# UNITED STATES PATENT AND TRADEMARK OFFICE

## Office Action Summary

This is the first office action for application number 10/611,956, Rotary Supporting Base for a Display Device, filed on July 3, 2003.

Patent number 5,518,216 to Wu.

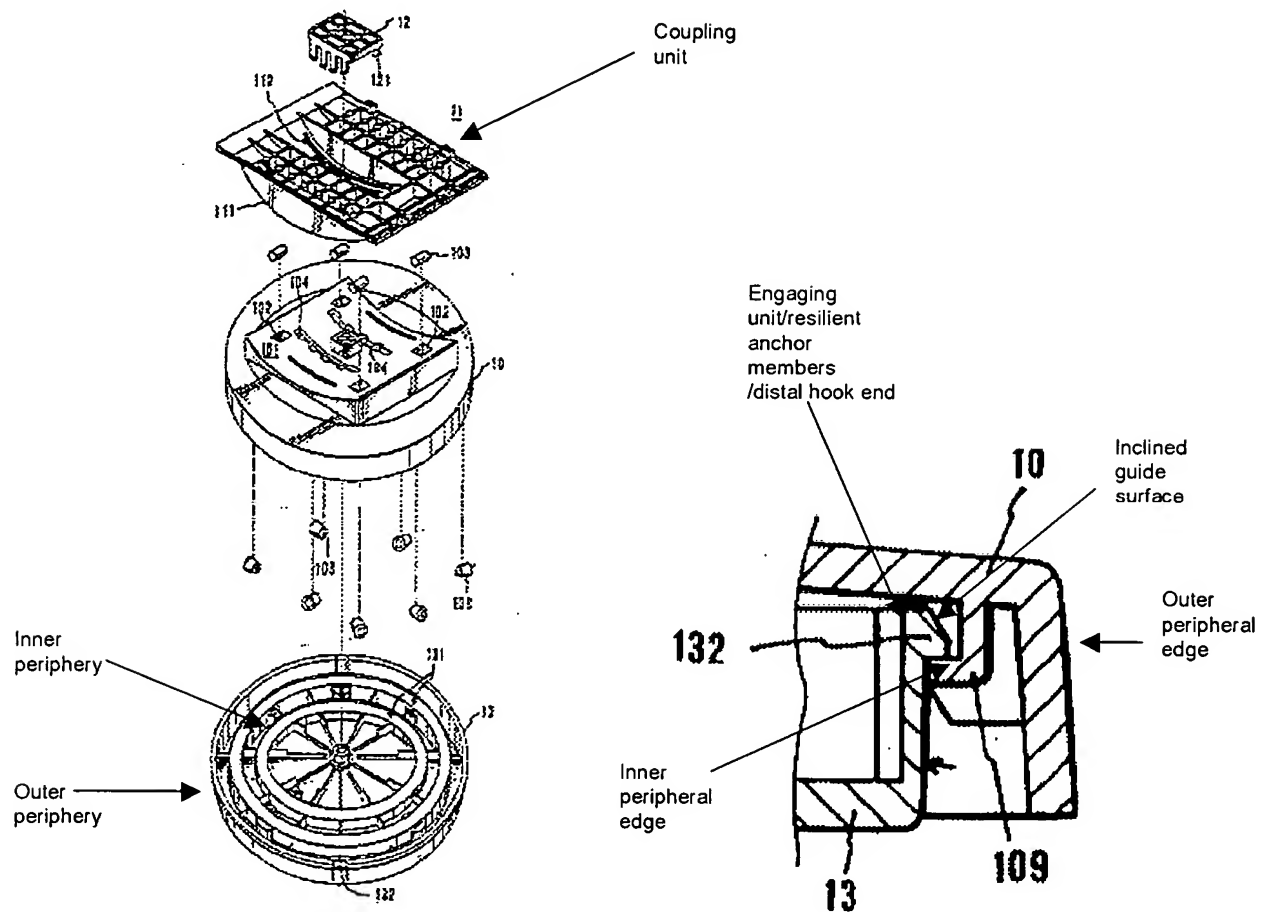
Claims 1-3 are rejected under 35 U.S.C. 102(b) as being anticipated by U.S.

Wu '216 discloses a rotary supporting base (figure 1) comprising a stationary lower base member (13) having a top surface formed with a ring-supporting region that is confined by an inner periphery and an outer periphery (above) that is concentric with and that surrounds said inner periphery, said lower base member being further formed with an engaging unit (above) on at least one of said inner and outer peripheries; a

coupling ring plate (10) disposed on said top surface of said lower base member at said ring-supporting region and rotatable relative to said lower base member about a rotary axis transverse to said top surface of said lower base member, said coupling ring plate having inner and outer peripheral edges (above), at least one of which is in sliding engagement with said engaging unit to retain rotatably said coupling ring plate on said top surface of said lower base member; a rotatable upper base member (11) disposed on top of said lower base member and coupled to said coupling ring plate for co-rotation therewith relative to said lower base member; and a coupling unit (above) provided on at least one of said coupling ring plate and said upper base member; wherein said engaging unit includes a plurality of resilient anchor members (above), each of which extends uprightly from said top surface of said lower base member and has a distal hook end (above) spaced apart from said top surface of said lower base member, said distal hook end abutting against said coupling ring plate to arrest upward movement of said coupling ring plate away from said lower base member; wherein said distal hook end of each of said anchor members has an inclined guide surface (above) that guides downward movement of said coupling ring plate toward said ring-supporting region on said top surface of said lower base member.

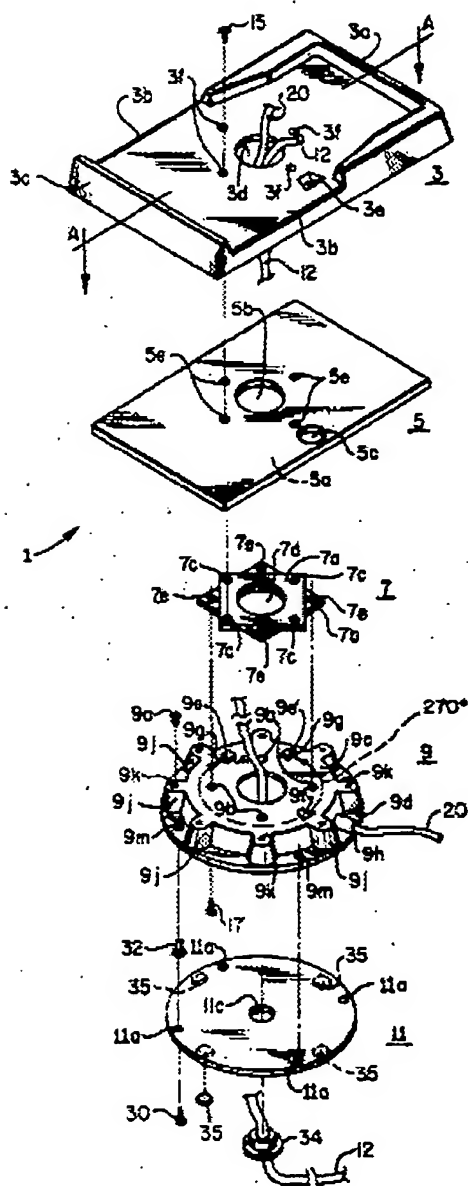
Claims 1 and 4-6 are rejected under 35 U.S.C. 102(b) as being anticipated by U.S. Patent number 3,936,026 to Hampel et al.

Hampel et al. '026 discloses a rotary supporting base (figure 1) comprising a stationary lower base member (7b) having a top surface formed with a ring-supporting region that is confined by an inner periphery and an outer periphery (outer edge and race of ball bearing race on line 54, column 3) that is concentric with and that surrounds

said inner periphery, said lower base member being further formed with an engaging unit (ball bearing race, column 3, line 54) on at least one of said inner and outer peripheries; a coupling ring plate (7a) disposed on said top surface of said lower base member at said ring-supporting region and rotatable relative to said lower base member about a rotary axis transverse to said top surface of said lower base member, said coupling ring plate having inner and outer peripheral edges (race of ball bearing race and the outer edge of plate), at least one of which is in sliding engagement with said engaging unit to retain rotatably said coupling ring plate on said top surface of said lower base member; a rotatable upper base member (5) disposed on top of said lower base member and coupled to said coupling ring plate for co-rotation therewith relative to said lower base member; and a coupling unit (3) provided on at least one of said coupling ring plate and said upper base member, further comprising a plurality of screw fasteners (15) for fastening said coupling ring plate to said upper base member; wherein said coupling ring plate is formed with a plurality of fastener holes, and said upper base member is formed with a plurality of screw sockets registered with said fastener holes, said screw fasteners extending through said fastener holes and engaging said screw sockets, respectively; wherein said coupling unit includes an outer tube segment (clearly, member 3 could inherently be a "segment" of an "outer tube" if for instance an outer tube was fitted through opening 3d) extending uprightly from said upper base member.
